Title: Product information - Intergas Viton front seal replacement program

Date issued: 14 Feb 2022

Front plate seal images and seal location

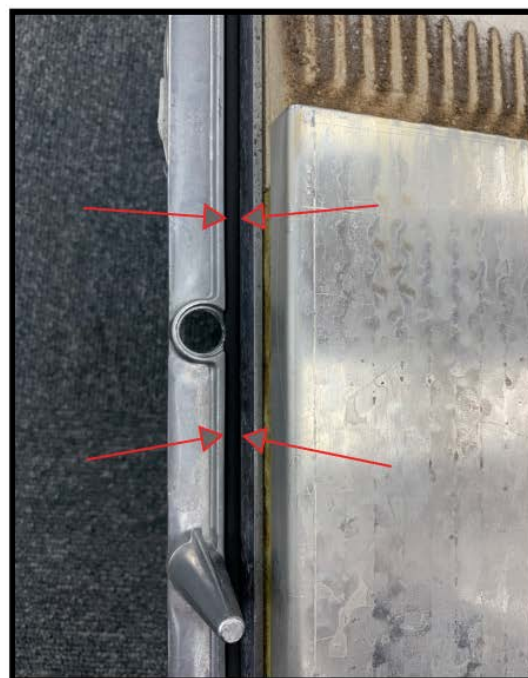
Black Viton front plate seal with seal replaced sticker

Old type Silicon red seal (do not use)

Rear of Front Plate showing Black Viton seal correctly located within the recess.

- 086474 Large Viton black seal (Replaces 876597 red Silicon seal)
- 086504 Medium Viton black seal (Replaces 877927 red Silicon seal)
- 086514 Small Viton black seal (Replaces 876467 red Silicon seal)
